Project No. W1547-06-01 *Revised May 8, 2023*

Subject: RESPONSE TO SOILS REPORT REVIEW LETTER

PROPOSED CHAMINADE HIGH SCHOOL IMPROVEMENTS 7500 N. CHAMINADE AVENUE, 23241 W. COHASSET STREET,

City of Los Angeles Geology and Soils Report Review Letter, Log No. 124921, dated

GEOLOGIC MAP (NORTH CAMPUS)

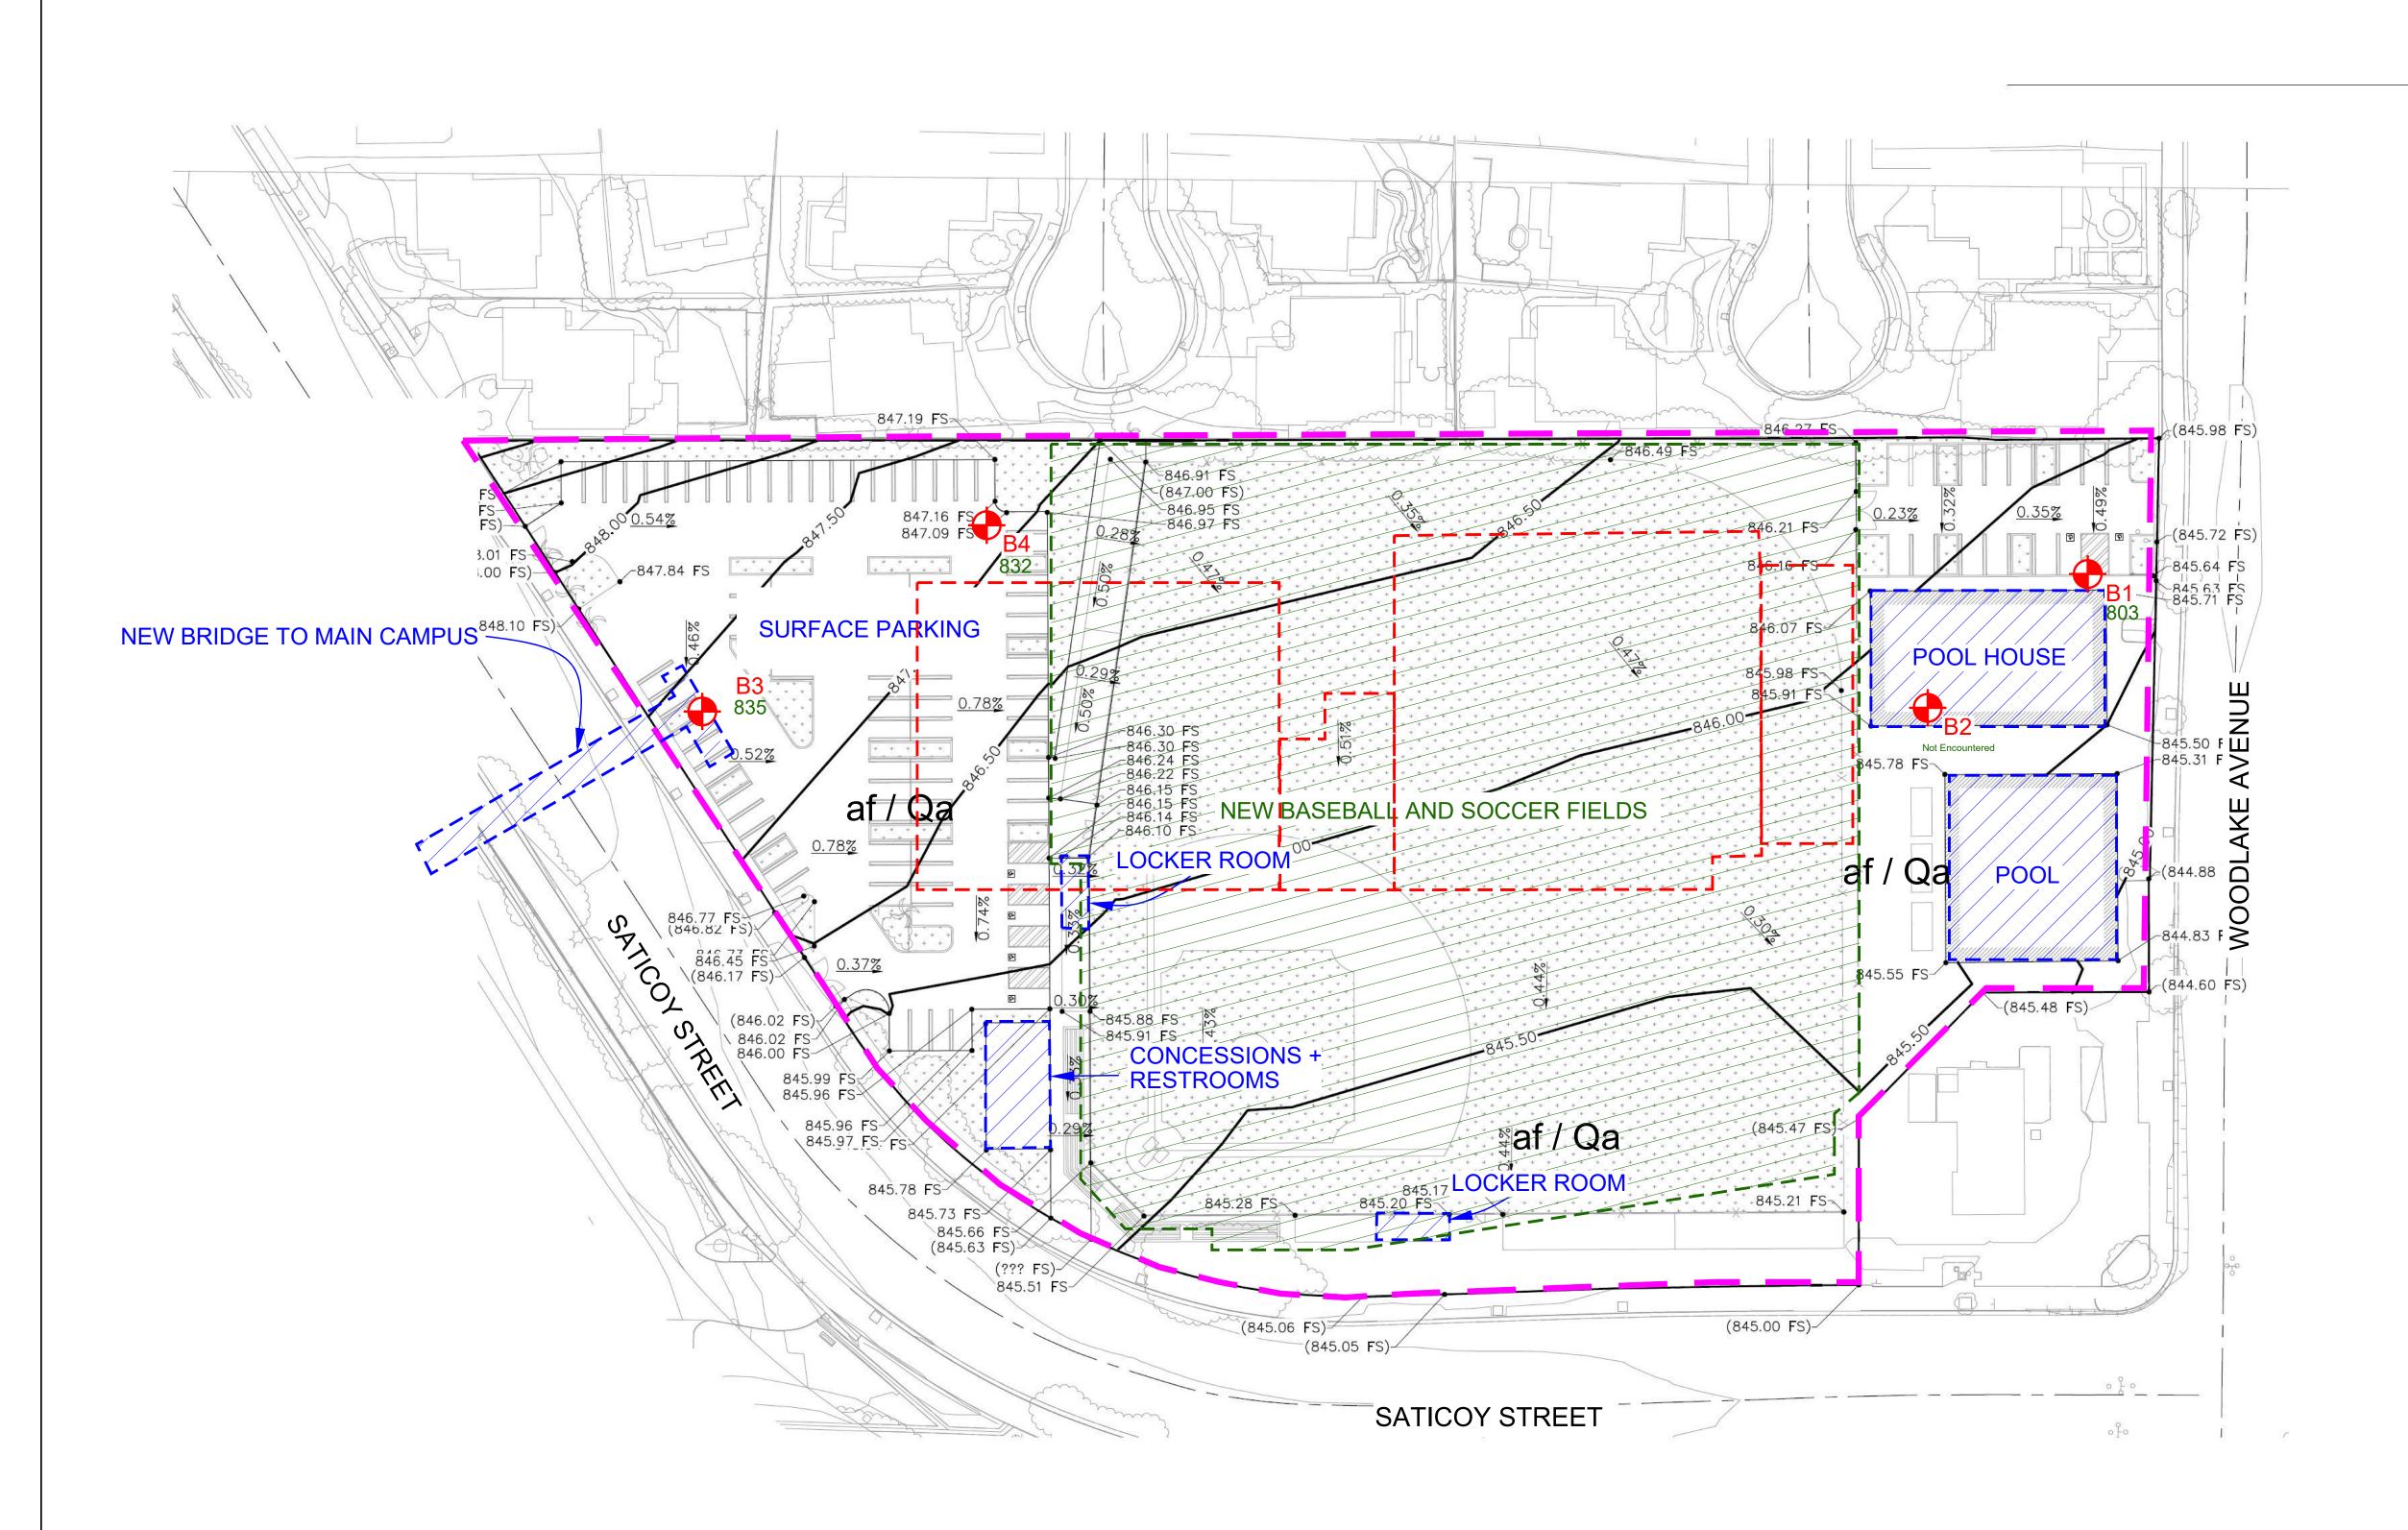
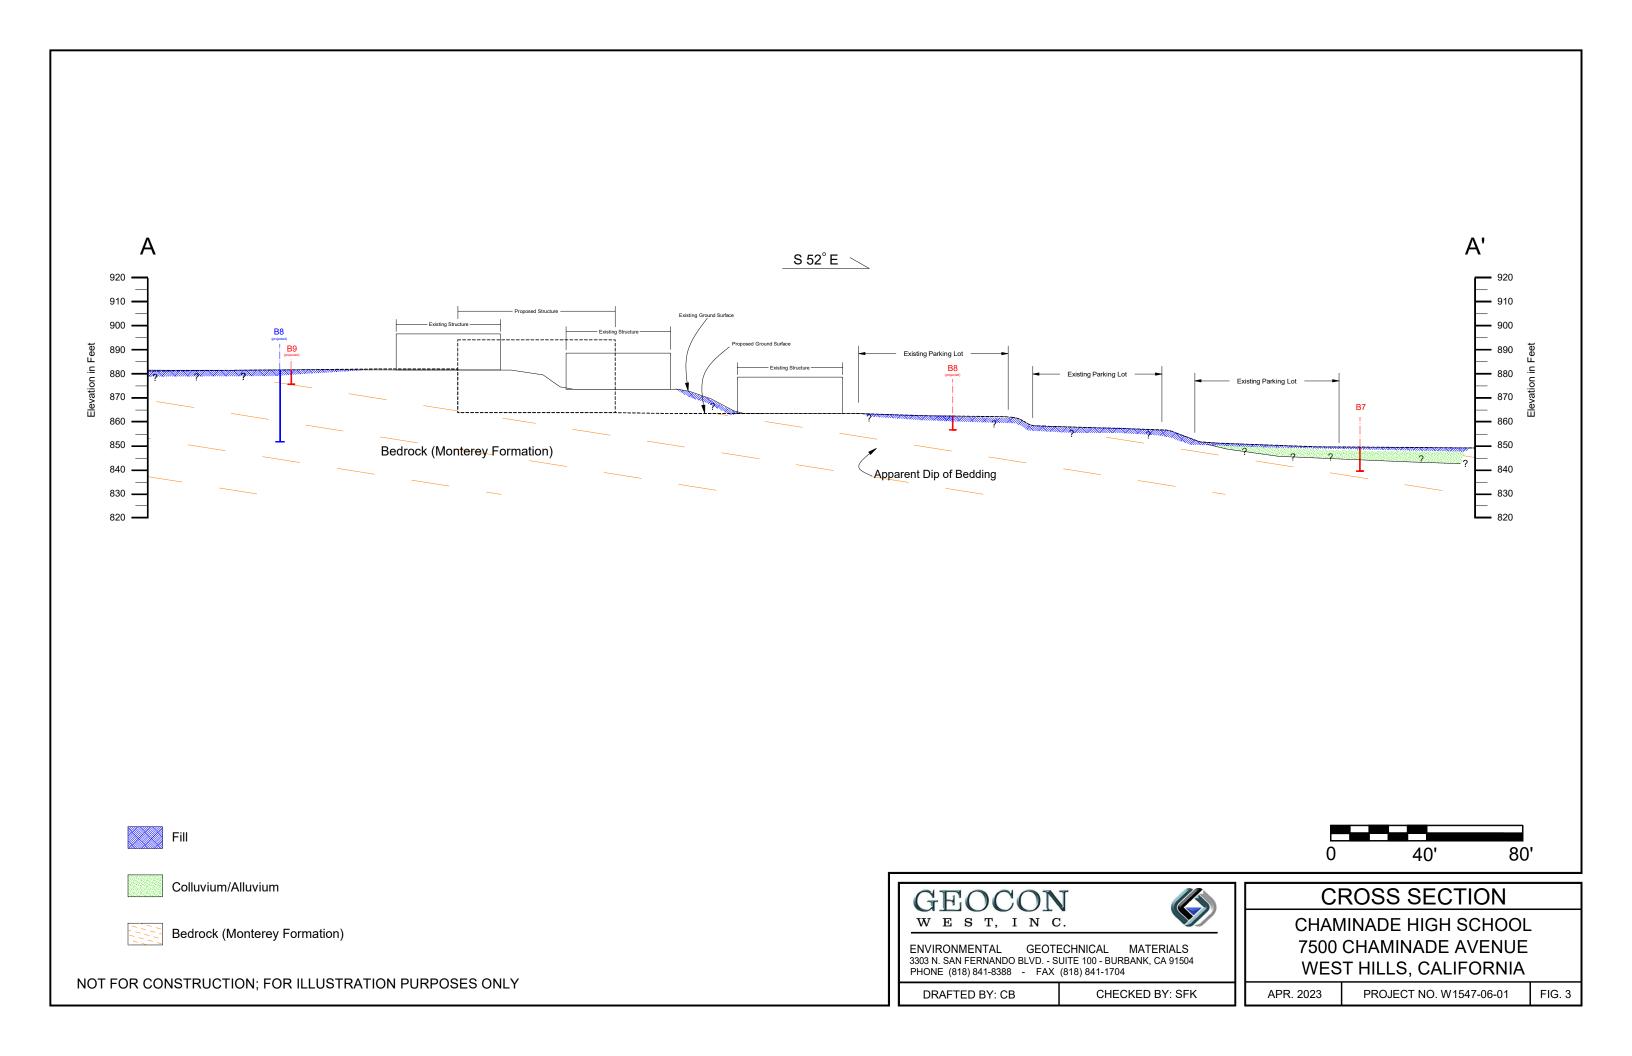
- Comment 2: Provide a geologic map that is based upon conceptual grading or site development plans, to illustrate all proposed and existing contours relative to the planned grading and/or construction, along with all off-site slopes and conditions that could adversely affect the stability or safety of the site (7006.3.2).

- Comment 4: Verify the location of the borings on the maps and cross sections, and revise accordingly.
- **Response 4:** Boring Locations have been reviewed and are correctly located on the Geologic maps and cross sections (see Figures 2A, 2B and 3).

Comment 8: For other than the Pool House, provide foundation recommendations for the proposed structures within the "North Campus" as shown on FIG. 2A, and for any proposed structures within the southern portion of the "Main Campus" (see FIG. 2A). Note: The foundation recommendations shall comply with the settlement thresholds for liquefaction based on P/BC 2020-151.

- Response 2: A Geologic Map of the Main and North Campus is provided on Figures 2A and 2B, respectively. Artificial fill is the surface material at the site and is underlain by either Holocene age alluvium or Tertiary age bedrock of the Monterey Formation. The geologic units are designated as artificial fill over alluvium (af/Qa) or artificial fill over shallow Monterey Formation (af/Tm).

Response 8: A summary of the proposed structures, recommended foundation system and recommended bearing materials is provided in the table below. Revised recommendations for the North Campus structures based on the results of the revised liquefaction analysis are also provided below.
